GENERAL APPLICATION

Location Address: 1604 Cleveland St. Hollywood, FL 33020

The following are the responses to your plans review comments of the above mentioned project:

NEW TOWNHOUSE FOR:
CLEVELAND HOMES LLC.
1604-1606 CLEVELAND ST.
HOLLYWOOD, FL 33020

1 Level 1
1/8" = 1'-0"

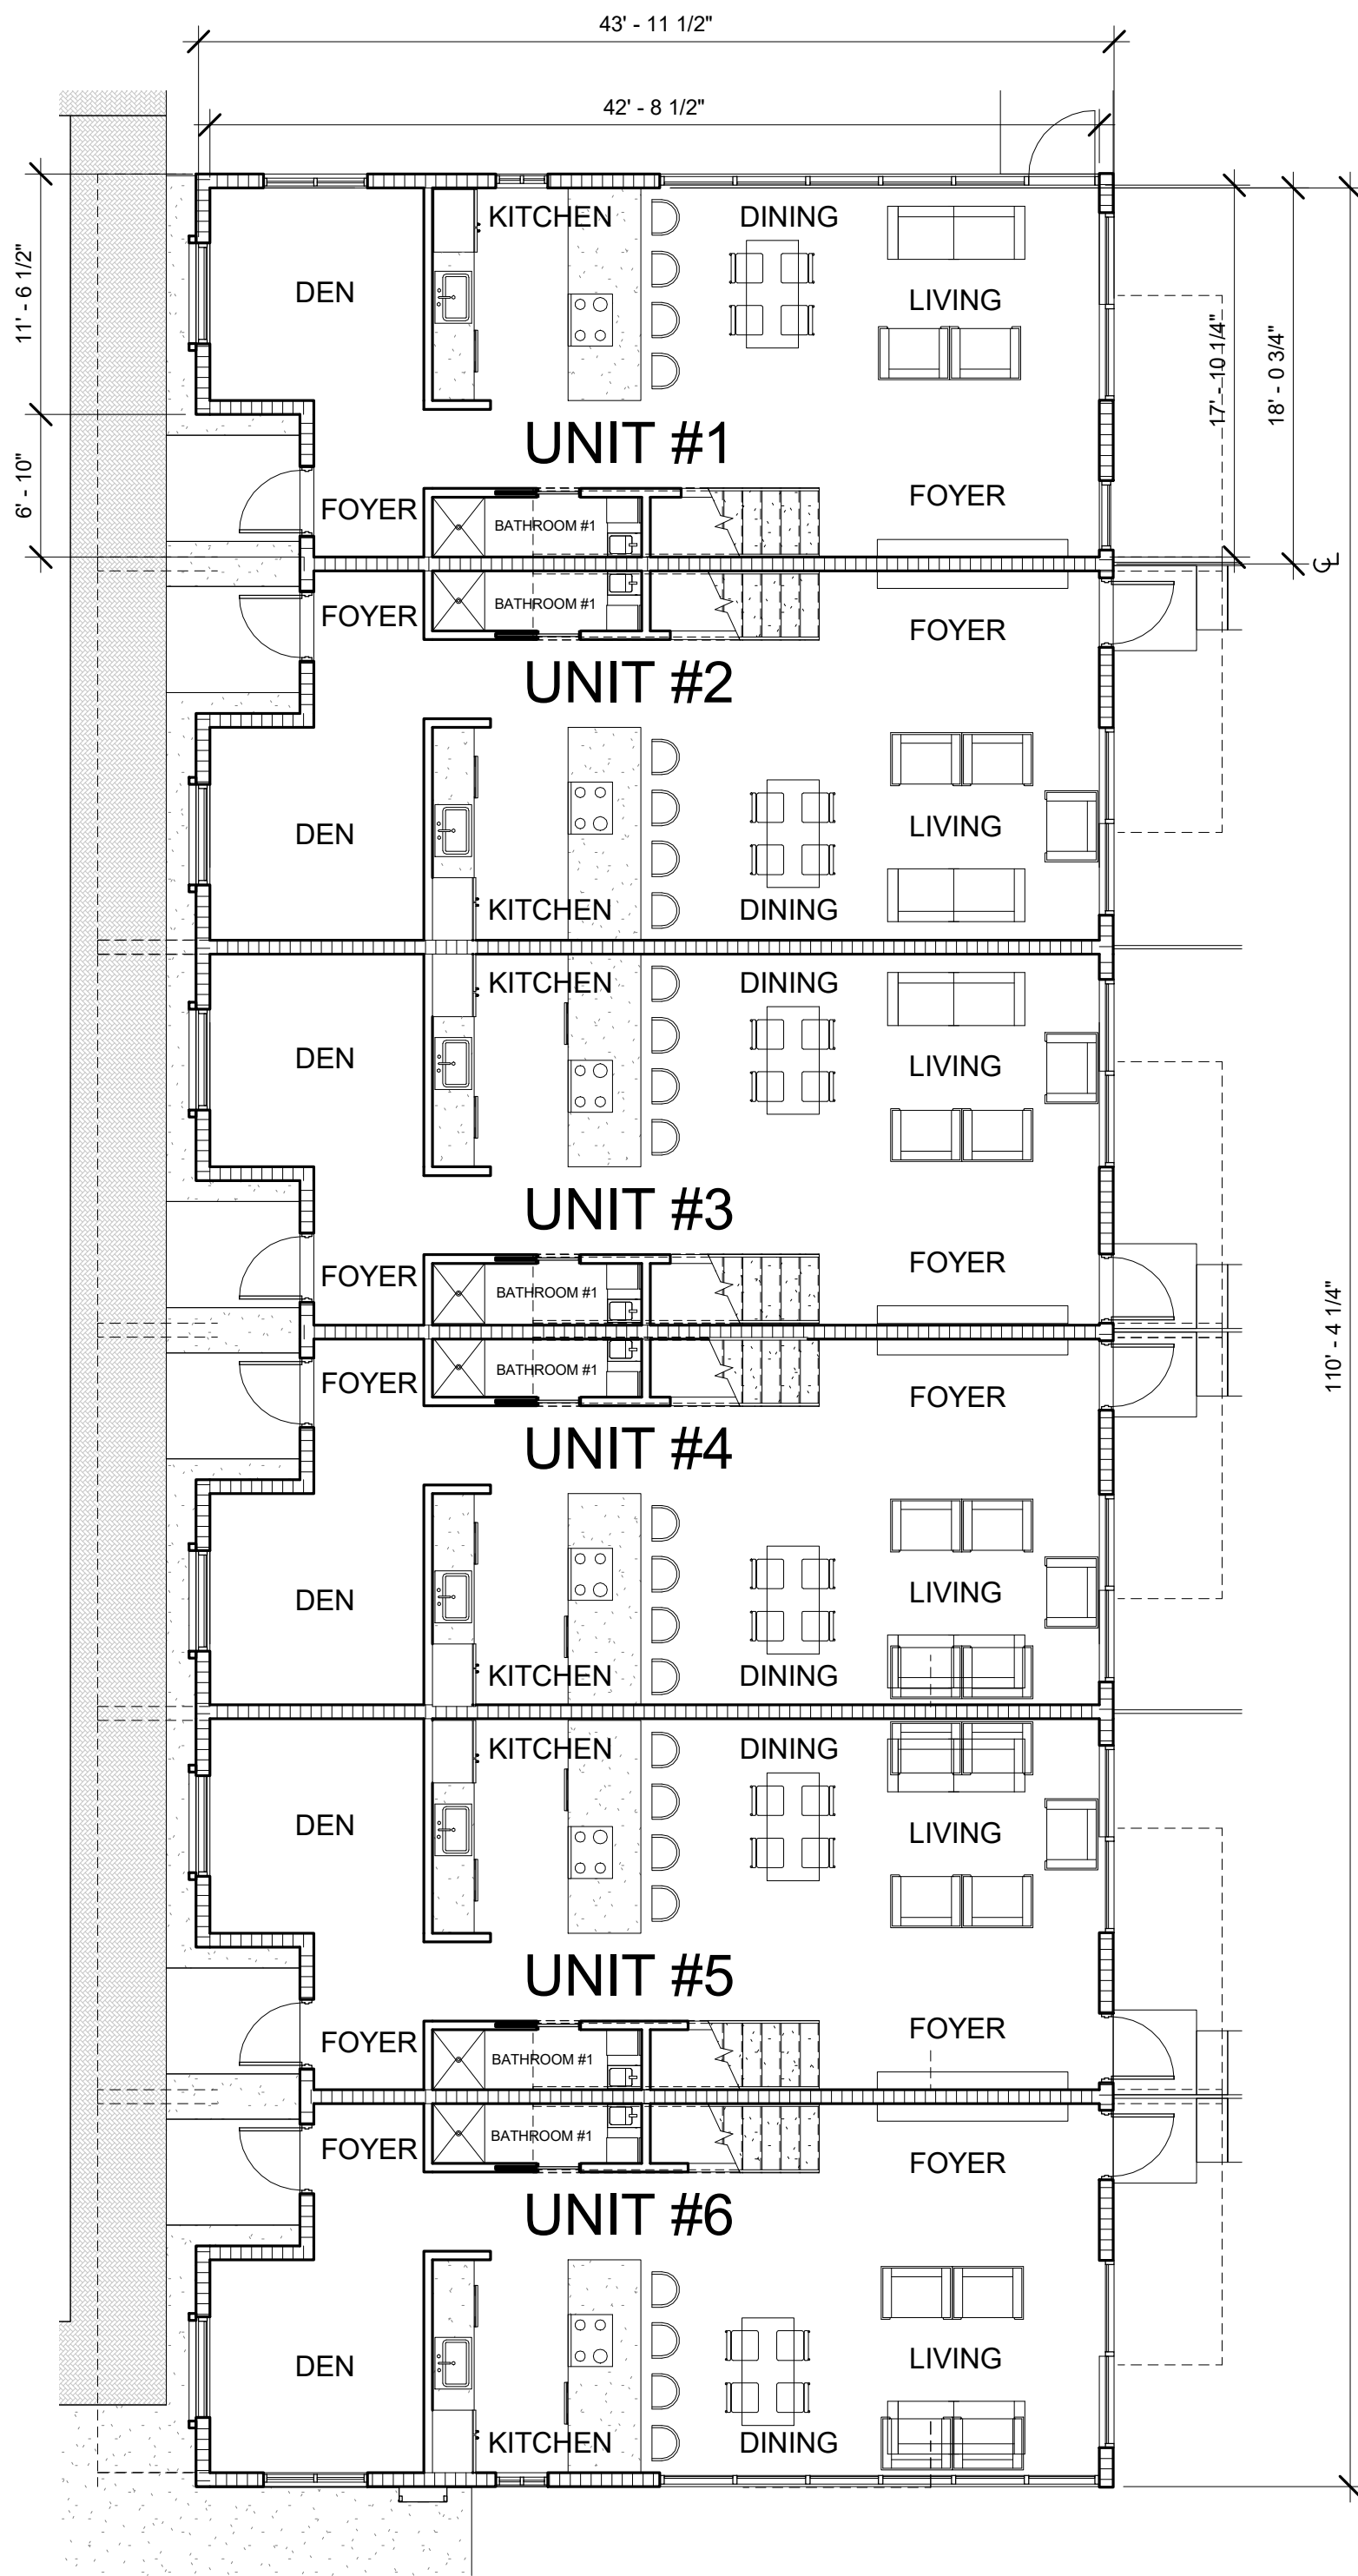
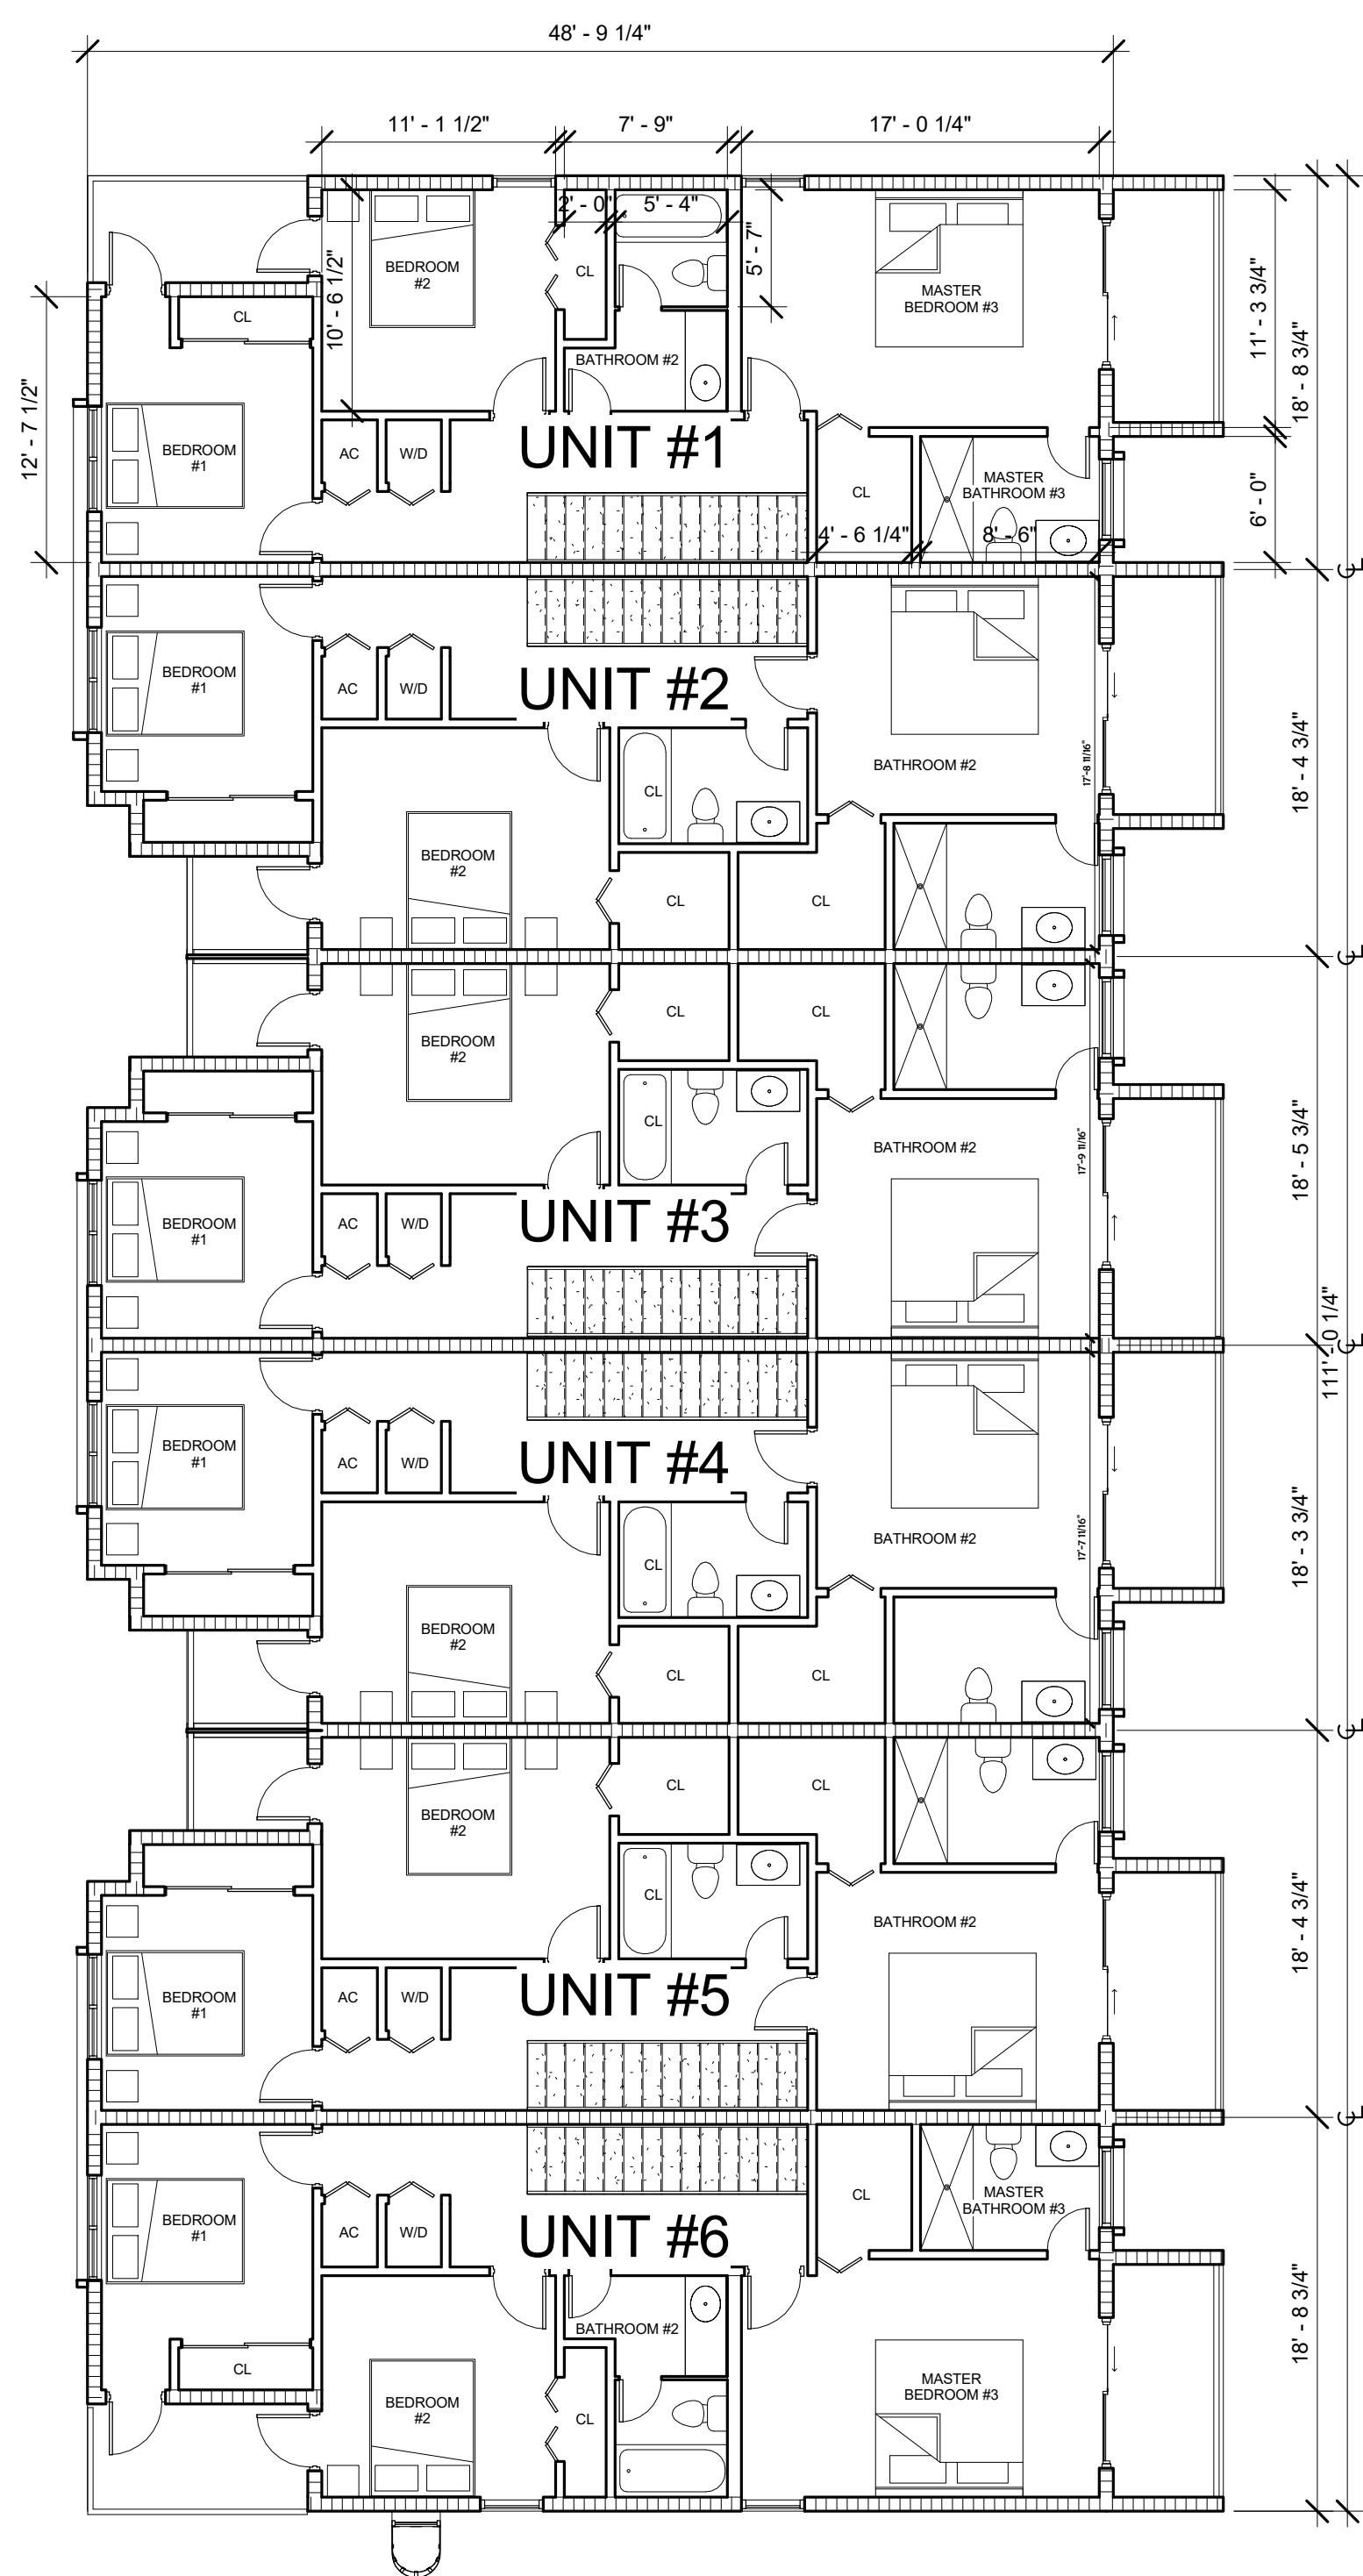
5. Sheet A2.0: What is the purpose of Bathroom #1? It doesn't have a toilet and it has a shower.

4. Sheet A2.0:

- a. Show bathroom details of Units #4 & #5.
- b. Why does second bathroom of Unit #1 & #6 have stall showers and the other units all have tubs in the second bathroom? Consider putting tubs in all the second bathrooms
- c. Unit numbers are labeled incorrectly

R: See revised plans.

1 ROOF PLAN
1/8" = 1'-0"

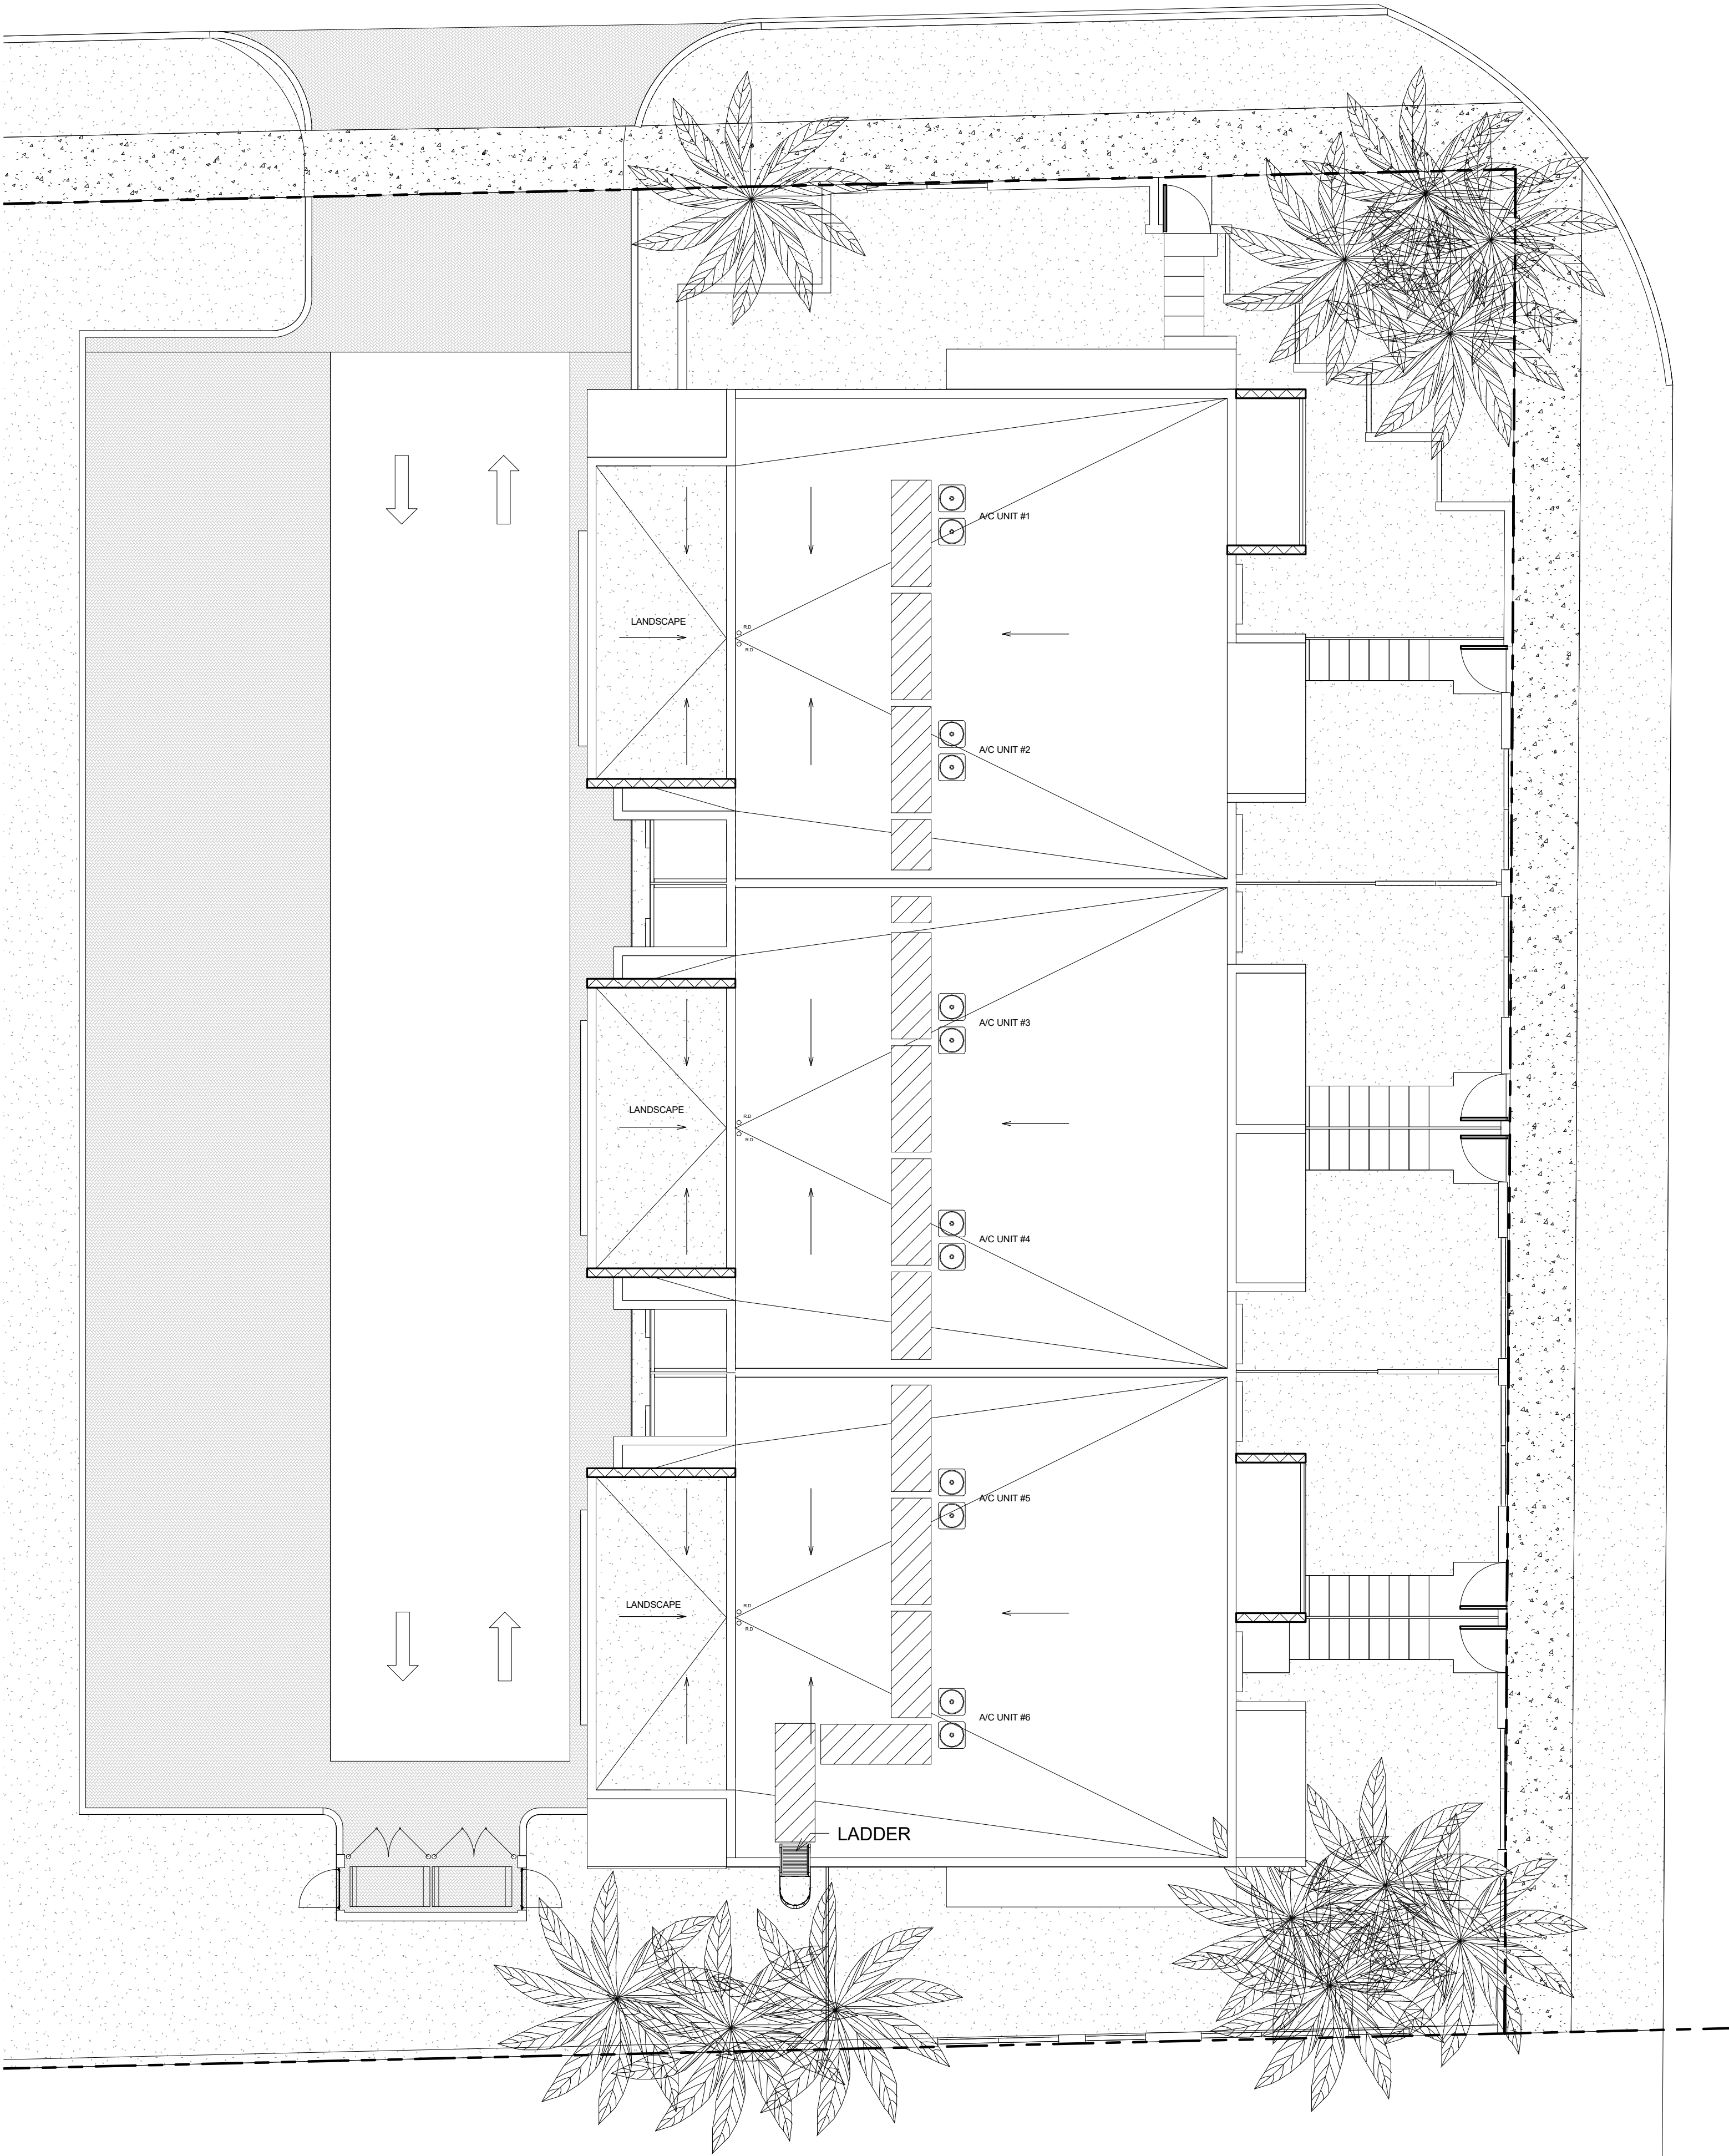
7. Sheet A-7.0: How are the roofs drained? No Roof Plan included in the set.

6. Sheet A7 – roof has parapet. Consider relocating mechanical equipment to roof to decrease noise in rear/side yards

R: See roof plan now provided.

R: See revised floor plans. (REMIND MIGUEL)
